INITIAL FIRE SAFETY INSPECTION REPORT

RIB LINE LTD New Location

RSC ID: 26590

Date: 03-March-2026

F-02

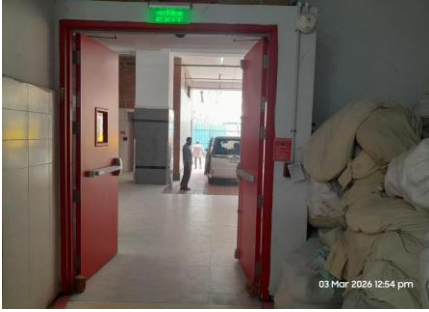
Aisles were found missing in several locations throughout the building.

Location(s): 9th floor (Garments Building).

Provide minimum aisle widths of 36-in. Aisles mark shall be clearly visible.

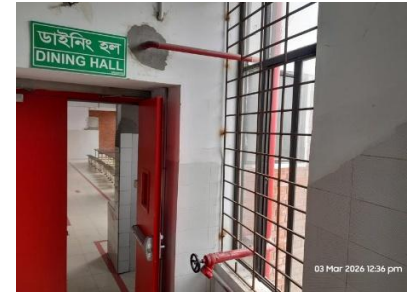
F-27	Fire Rated Construction	The required fire separation distance for the Garments Building does not comply with the requirements of BNBC 2020. Location(s): Garments Building.	The exterior walls shall have a fire resistance and opening protection as specified in BNBC 2020 Part 3 Table 3.2.2 & 3.2.3 and BNBC 2020 Part 3 Section 2.4.1.3.	Within 6 Months

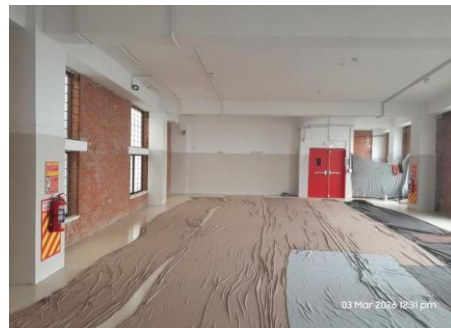
F-31	Means of Egress	Aisles were found missing in several locations throughout the building. Location(s): 1st floor, 4th floor, etc. (Utility Building).	Provide minimum aisle widths of 36-in. Aisles mark shall be clearly visible.	Within 1 Month
------	-----------------	--	---	-----------------------

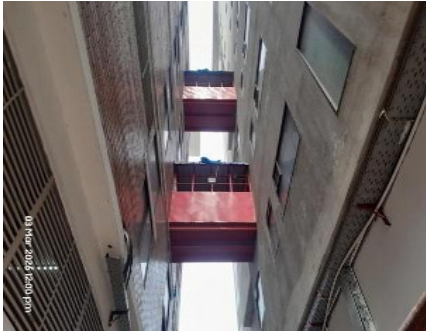
F-35	Means of Egress	Exit sign not provided at exit. Location(s): Ground floor, Utility Building.	Lighted exit signs shall be placed at entrance to an exit. Additional directional exit signs shall be placed throughout the facility anywhere the continuation of the egress is not obvious. Lighted exit signs shall be provided with either battery backup or uninterruptable power supply systems and shall be continuously illuminated at all times. Exit Sign shall provide in accordance with RSC Technical Guidelines (Standard)¹ V1.0 Section 6.11.	Within 1 Month
